CITY OF ALBUQUERQUE

PLANNING DEPARTMENT – Development Review Services

RE: American Toyota (File: C18D012)
Grading and Drainage Plan, Engineer's Stamp Date 7-22-15
Engineer's Certification Dated 4-20-16

ENGINEER'S SEAL  7/22/15 DAVID SOULE P.E. #14522	AMERICAN TOYOTA GRADING AND DRAINAGE PLAN <i>Rio Grande Engineering</i> 1806 CENTRAL AVENUE SE SUITE 201 ALBUQUERQUE, NM 87106 (505) 872-0999	DRAWN BY WCWJ
		DATE 7-22-15
		21403-LAYOUT-1-25-14
		SHEET # — JOB # 21403

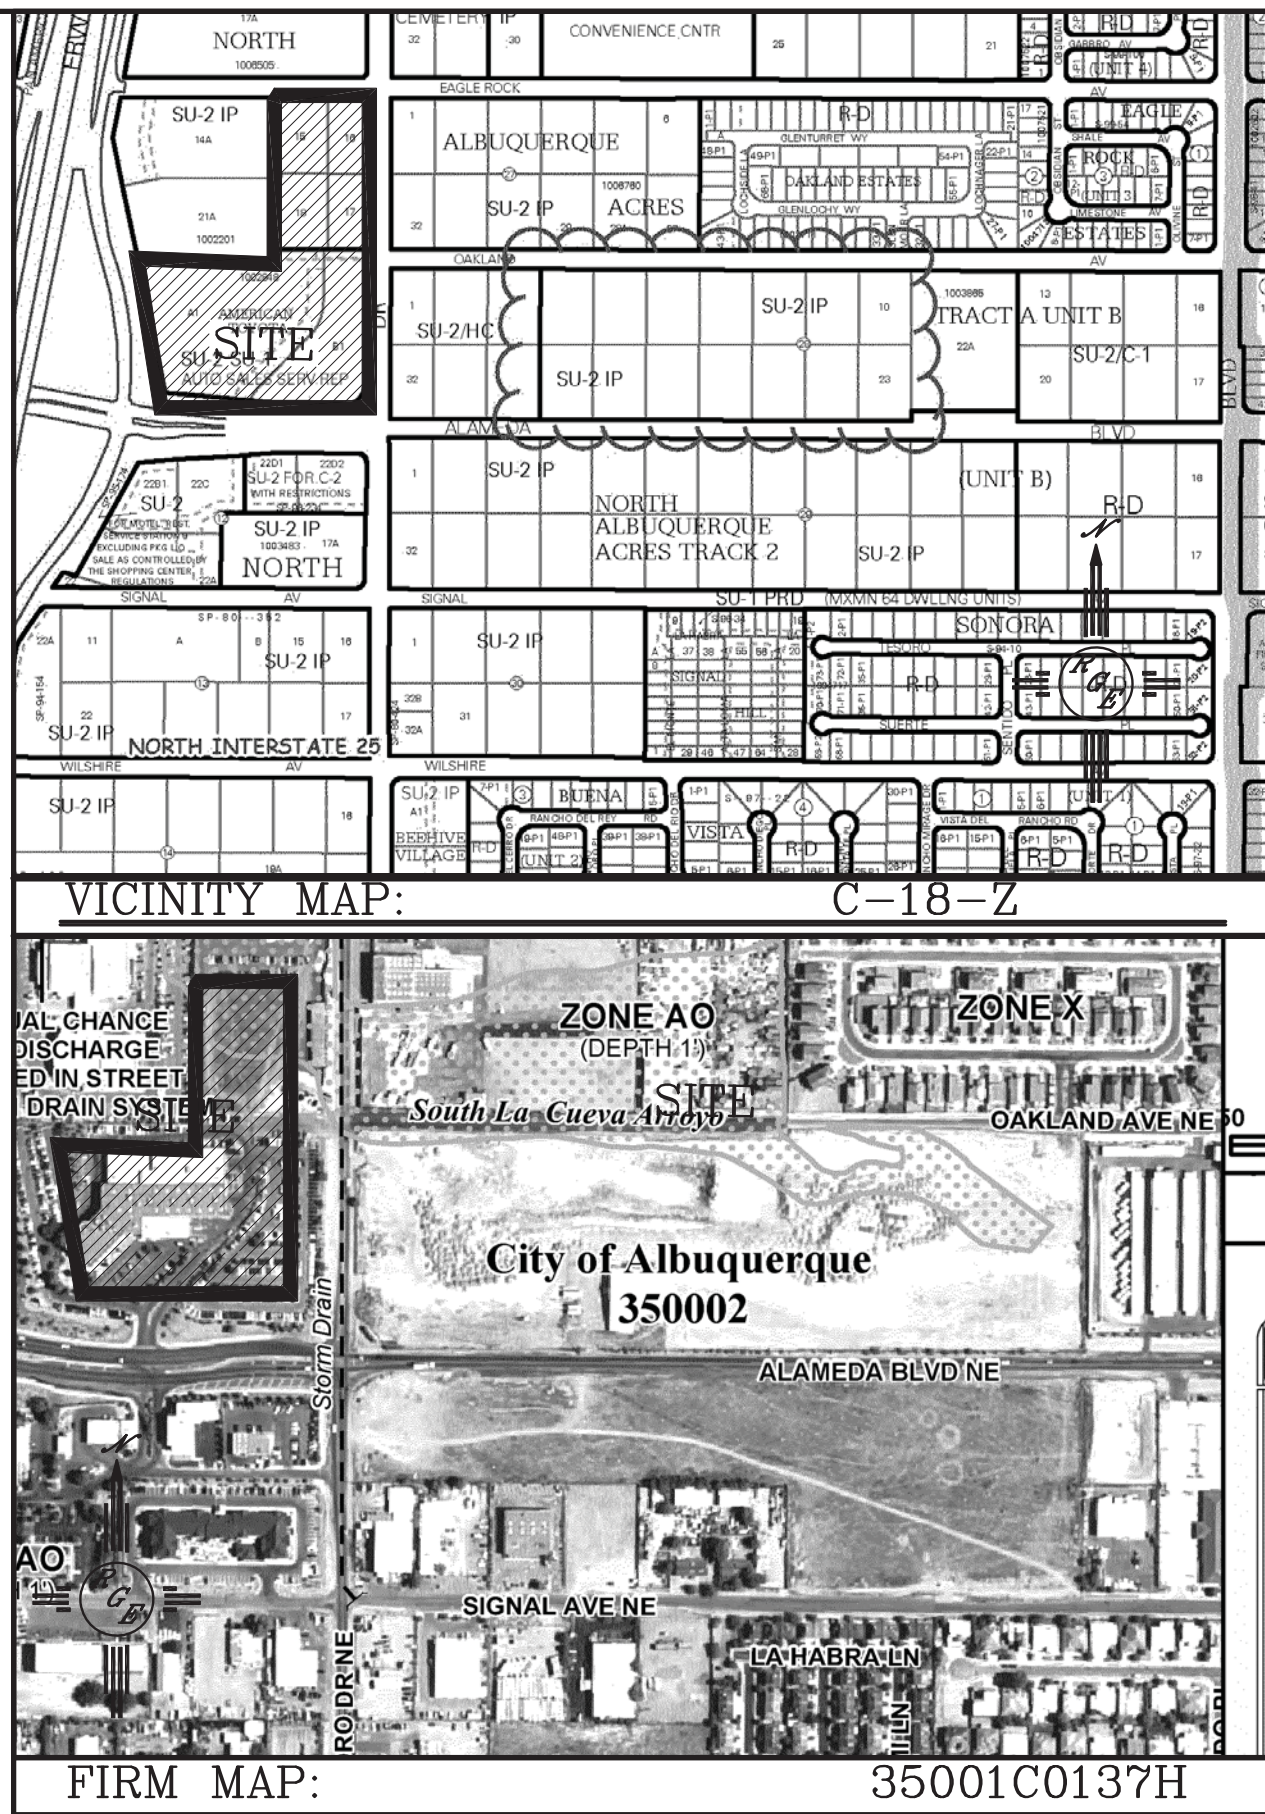
Based upon your Engineer's Certification received 4-21-16, the site is acceptable for a TEMPORARY 90-day Certificate of Occupancy by Hydrology with the following conditions:

- Existing inlets at NE corner, behind wall, need to be cleared of all debris and trash
- After 90-days, the NE corner should be graded and paved, and a subsequent TEMPORARY C.O. must be sought. This subsequent TEMPORARY C.O. should be given indefinitely, until the remainder of the site is complete.
- Once the entire site is complete, a Permanent C.O. should be sought. Until then, only Temporary C.O.'s will be issued.
- The Engineer's Certificate should include the addition of inlets and StormTec chambers that were added in the NW corner.
- If this project is to be phased, and it is intended to obtain Permanent C.O. after each phase, then intermediate grading plans are required.
